PCI-SIG ENGINEERING CHANGE NOTICE

TITLE:	Bridge Related Updates
DATE:	August 21, 2003
AFFECTED DOCUMENT:	PCI Express Base Specification, Rev 1.0a
SPONSOR:	Carl Jackson; Hewlett-Packard Company Sridhar Muthrasanallur; Intel Corporation

Figure 7-14: Device Control Register

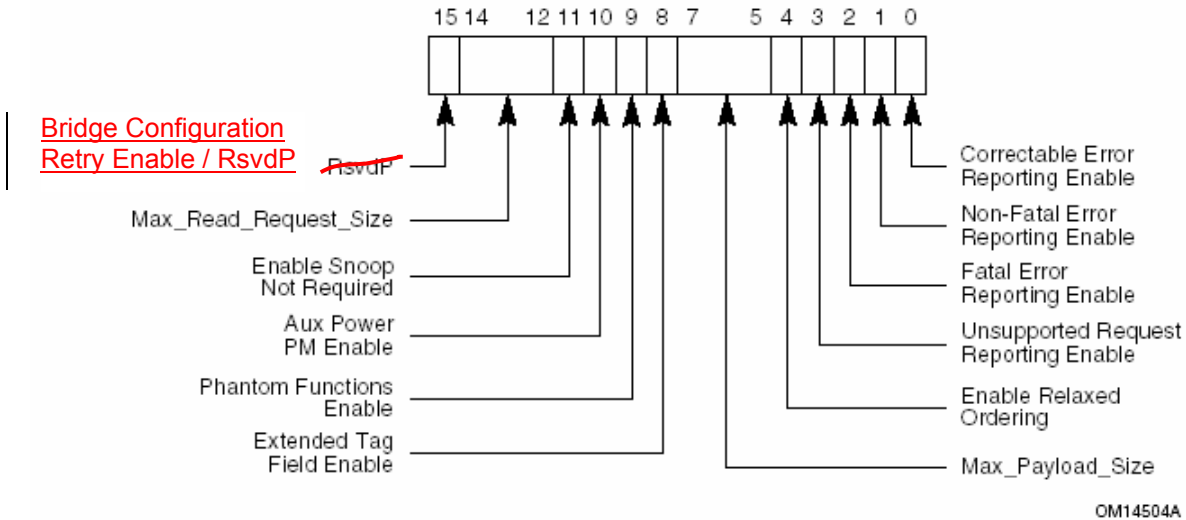
The following two changes update the PCI Express Base spec to show the usage by PCI Express to PCI/PCI-X Bridges of a previously reserved bit (bit 15) in the Device Control Register of the PCI Express Capability Structure. Software uses this bit to enable PCI Express to PCI/PCI-X Bridges to return Completions with Configuration Request Retry Status. Details are contained in PCI Express to PCI/PCI-X Bridge 1.0.

Section 7.8.4, p.341 – Modify Figure 7-14 as follows:
